ADDENDUM NO. 1

Date: 7/11/2017

Project: Field Improvements at West Campus High School

West Campus High School
Synthetic Practice Field & Road Improvements, Inc. 1

AD1-1

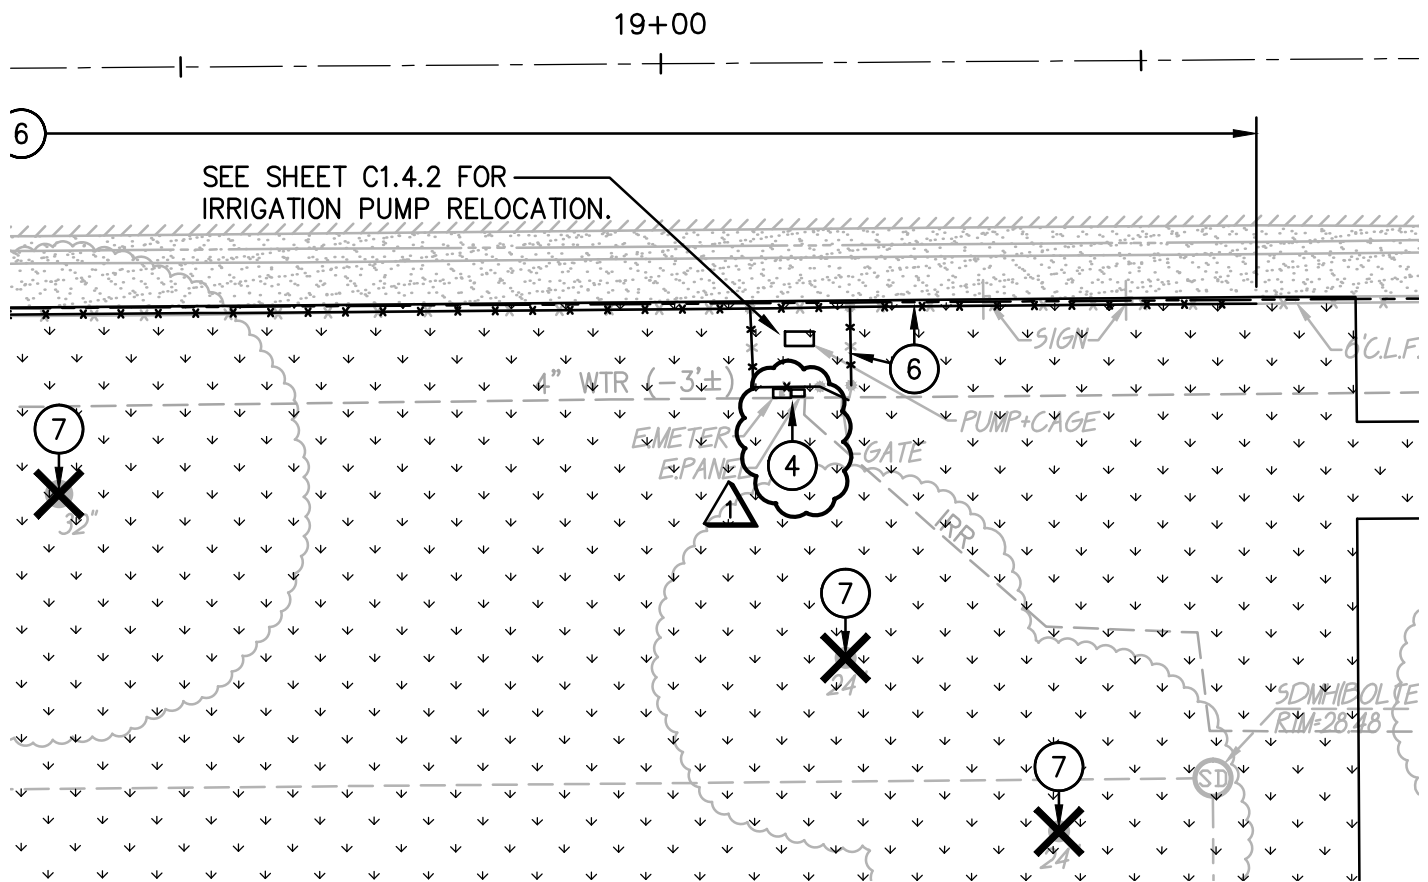
1. AD1-1 DEMOLITION PLAN
 - a. Note updated for SMUD meter to be relocated as well.
2. AD1-2 DEMOLITION PLAN
 - a. Backstops added to demolition.
3. AD1-3 GRADING PLAN
 - a. Existing light pole to be re-installed, location clarified.
4. AD1-4 POLE BASE DETAIL
 - a. Detail provided.
5. AD1-5 SITE DOMESTIC WATER AND FIELD IRRIGATION PLAN
 - a. Irrigation note added for clarification.
6. AD1-6 PAVING PLAN
 - a. Paving type added, paving type updated.

4. REMOVE AND RELOCATE EXISTING SMUD SERVICE FOR IRRIGATION PUMP SYSTEM. CONTRACTOR TO PROVIDE ALL TRENCHING, CONDUIT AND WIRE AS NEEDED. CONTRACTOR TO PROVIDE SMUD APPLICATION AND ALL FEES FOR SMUD TO RELOCATE SERVICE TO NEW PUMP LOCATION. SEE SHEET C1.4.2.

AD1-2

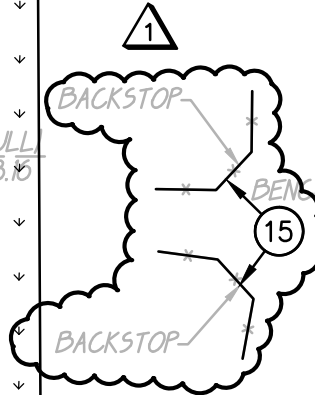
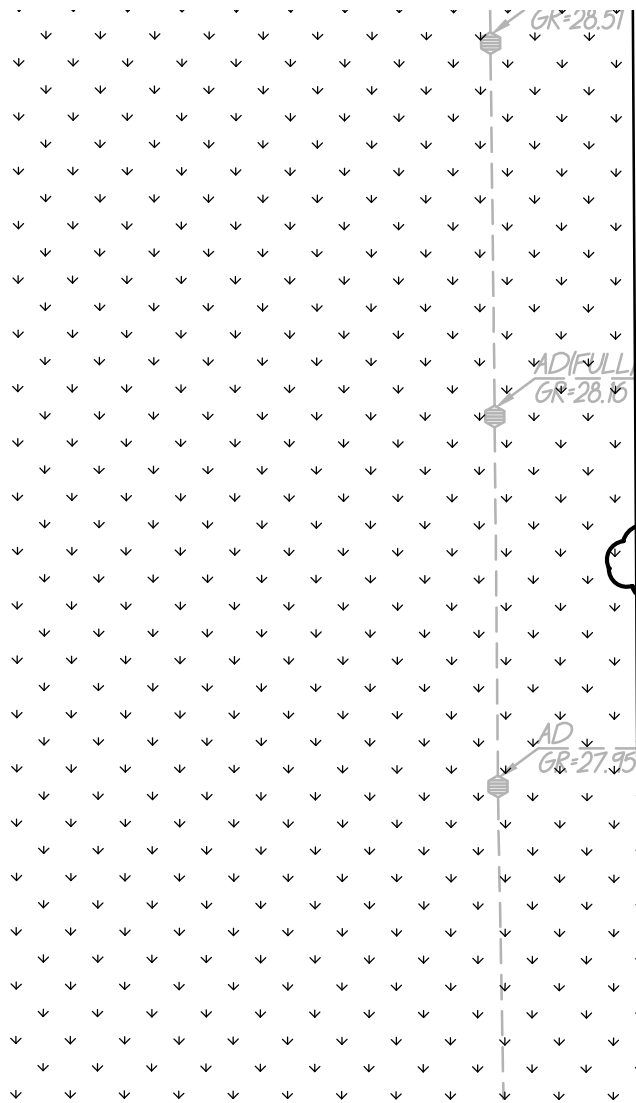
1 15. REMOVE EXISTING BACKSTOPS COMPLETE WITH ANY FOOTINGS.

AD1-3

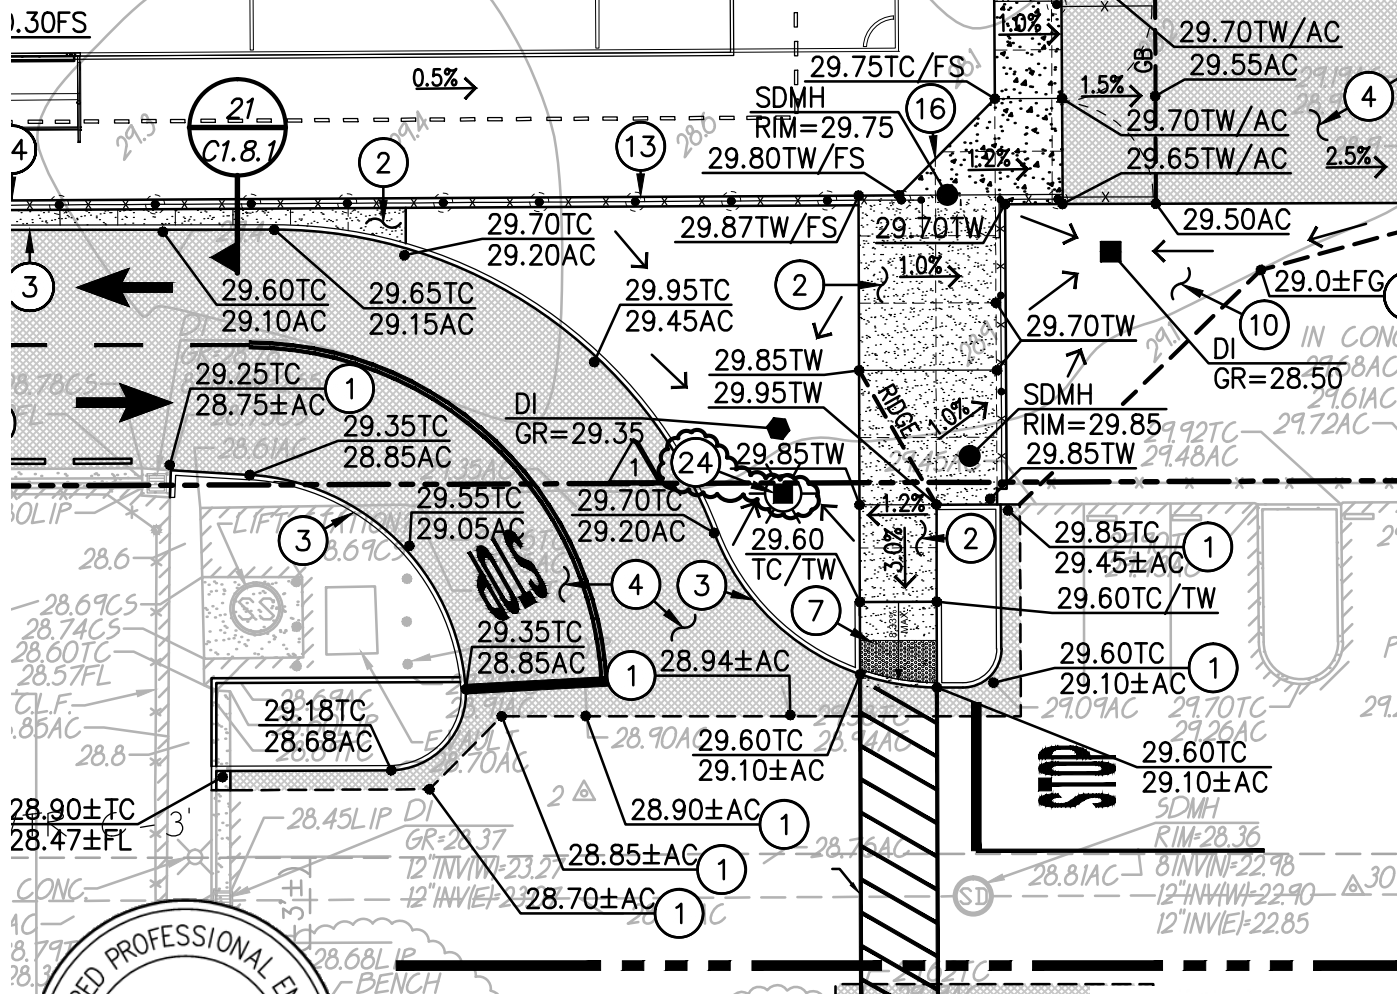
1. Identify and/or locate required temporary power on the drawings?
 - a. Refer to section 01 50 00 Temporary Facilities, 2.01 B for information about temporary power. There is no information regarding temporary power on the drawings.
2. Identify and/or locate required lighting on the drawings?
 - a. One light pole is to be relocated. See AD1-3 Grading Plan, note 24, and AD1-4 Pole Base Detail.

24. RE INSTALL LIGHT POLE ON NEW CONCRETE BASE AT LOCATION SHOWN. INCLUDE ALL NECESSARY CONDUIT AND WIRING TO RE-CONNECT TO (E) CIRCUIT.

AD1-5

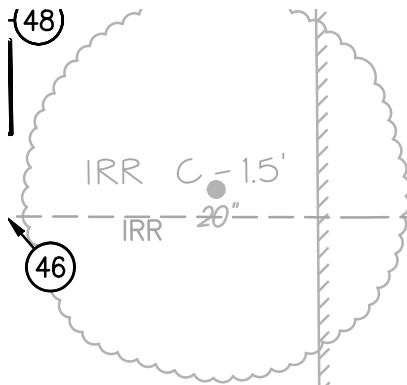
NOTE: CONTRACTOR TO PROVIDED FOR QUICK SWITCH-OVER OF THIS IRRIGATION PUMP AND MAIN RELOCATION SO AS NOT TO MISS AN IRRIGATION CYCLE, OR SHALL PROVIDE A TEMPORARY WATER CONNECTION OR TEMPORARY WATERING OF LANDSCAPED AREAS AFFECTED BY THIS PUMP SYSTEM RELOCATION. IRRIGATION MAIN IS EXPECTED TO FEED IRRIGATION SYSTEMS IN FRONT OF CAMPUS SO HAND WATERING OF THESE SYSTEMS WILL BE DIFFICULT AND NOT RECOMMENDED. CONTRACTOR SHOULD TAKE APPROPRIATE STEPS TO AVOID THIS UNLESS ABSOLUTELY NECESSARY. CONTRACTOR MAY CONSULT WITH DISTRICT MAINTENANCE STAFF TO DETERMINE AFFECTED SYSTEMS AND SHALL FIELD VERIFY BY OPERATING ZONES WITH DISTRICT, TO DETERMINE WHAT ZONES ARE DOWNSTREAM OF THIS PUMP AND IRRIGATION MAIN.

45. REMOVE AND RELOCATE EXISTING IRRIGATION PUMP ASSEMBLY TO NEW LOCATION SHOWN. PROVIDE ALL PIPE FITTINGS, COUPLERS AND ADAPTORS AS NEEDED. PROVIDED 4" THICK CONCRETE PAD ON 4" CLASS II AB FOR EQUIPMENT INSTALLATION. **RELOCATE**

AD1-6

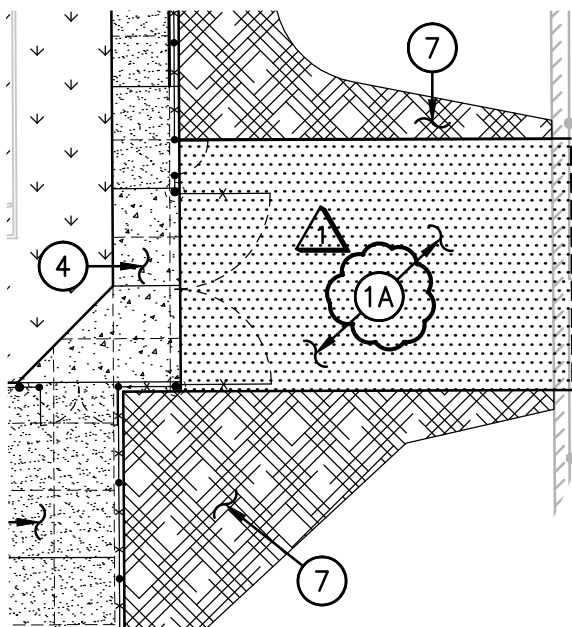
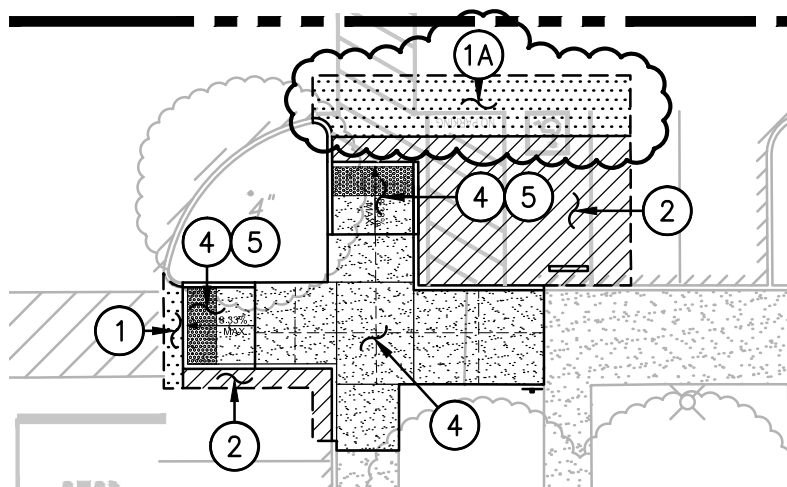
PLACE FIRST 2" LIFT OF 3.5" AC, OVER 13" AB ON COMPACTED SUBGRADE. FINAL 1.5" LIFT FOR COMPLETE 3.5" SECTION WILL BE PERFORMED BY OTHERS IN INCREMENT 2. DO NOT APPLY SEALCOAT. SUBGRADE SHALL BE PLACED AND COMPACTED PER SPECIFICATION SECTION 31 00 00. ASPHALT SHALL BE PER SPECIFICATION SECTION 32 12 16.

PLACE 3.5" AC, OVER 13" AB ON COMPACTED SUBGRADE. SUBGRADE SHALL BE PLACED AND COMPACTED PER SPECIFICATION SECTION 31 00 00. ASPHALT SHALL BE PER SPECIFICATION SECTION 32 12 16.

Sheet No. **AD1-7**

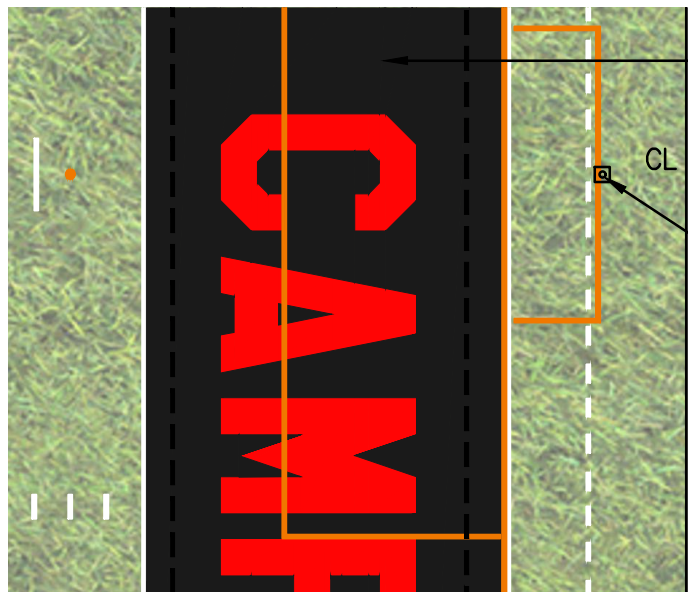
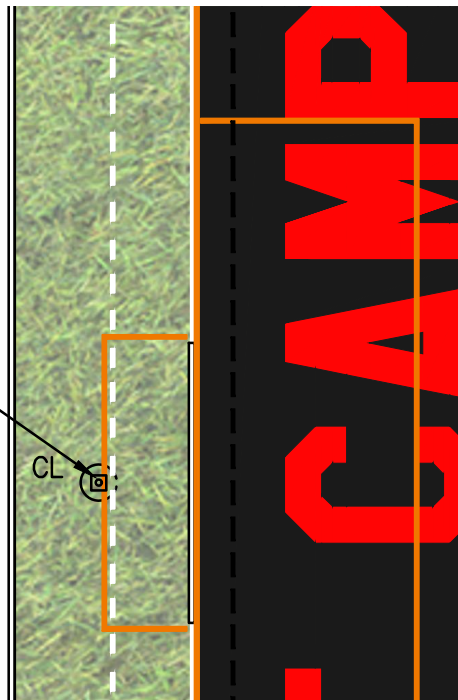
7. AD1-7 FIELD LAYOUT PLAN
 - a. Ground sleeves and soccer lock down to be installed at both goal ends.
8. AD1-8 FIELD FENCING AND EQUIPMENT PLAN
 - b. Only goal sleeves to be installed, goal posts to be provided but not installed.
9. AD1-9 FIELD FENCING SECTIONS AND DETAILS
 - c. Goal post to be provided but not installed.
10. C1.6.5 FIELD EQUIPMENT DETAILS
 - d. Some equipment not used.
11. C1.8.3 DETAILS AND SECTIONS
 - e. Field section detail updated.

1
 PROVIDE AND INSTALL COMBINATION
 GROUND SLEEVE AND SOCCER LOCK
 DOWN ONLY, SEE C1.6.3.

AD1-8

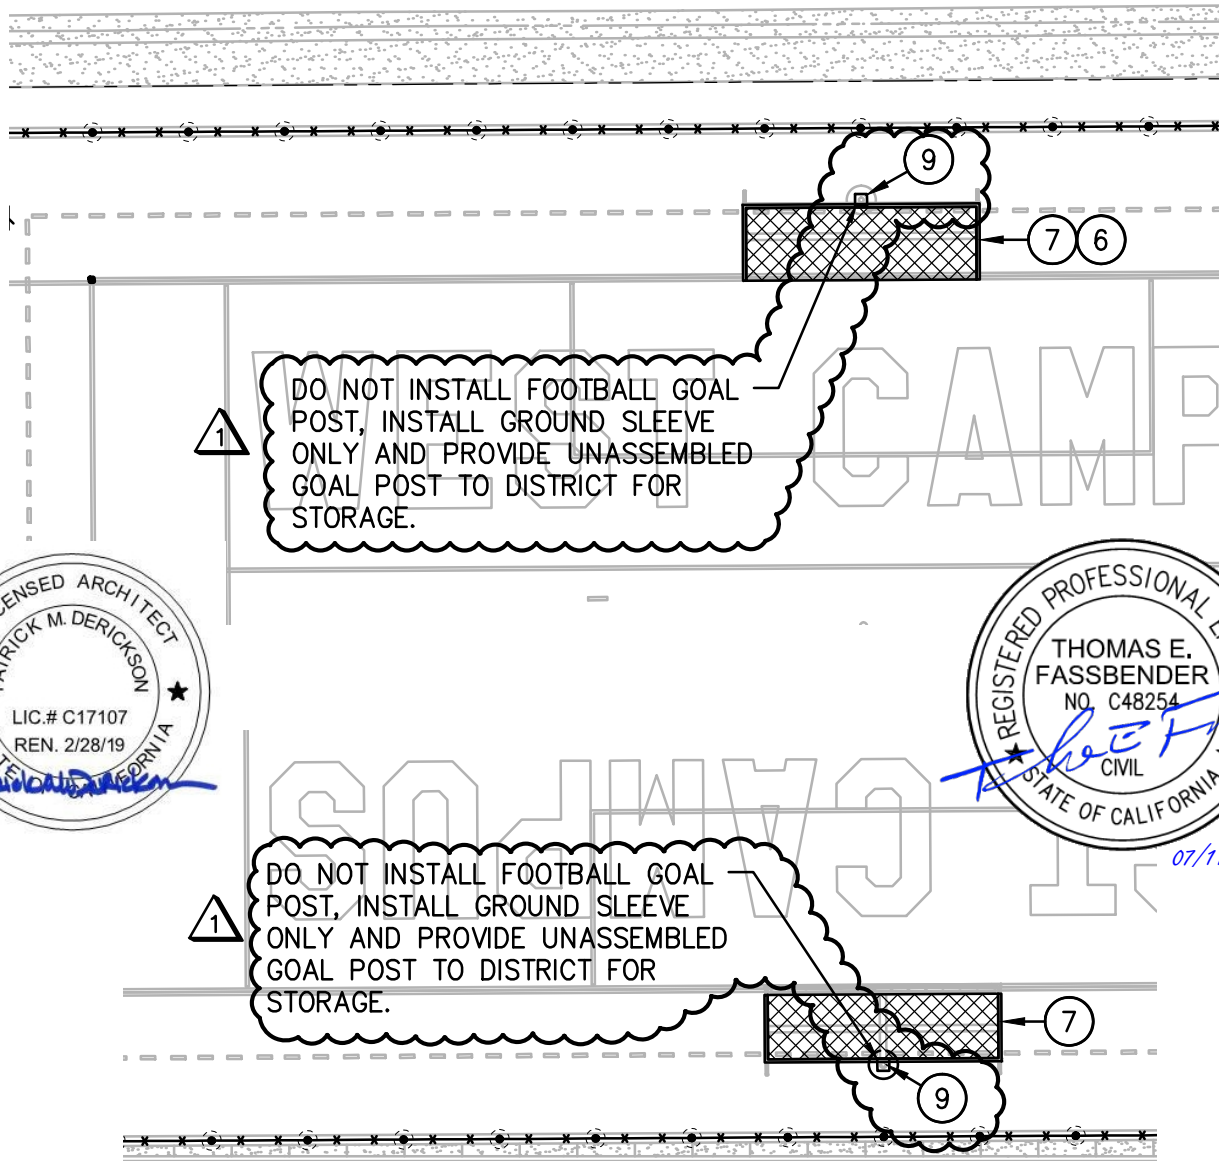
1. PROVIDE AND INSTALL SOCCER GOAL LOCK DOWN BOX. REFER TO SPECIFICATIONS SECTION 11 68 13.23 AND DETAIL PROVIDED.
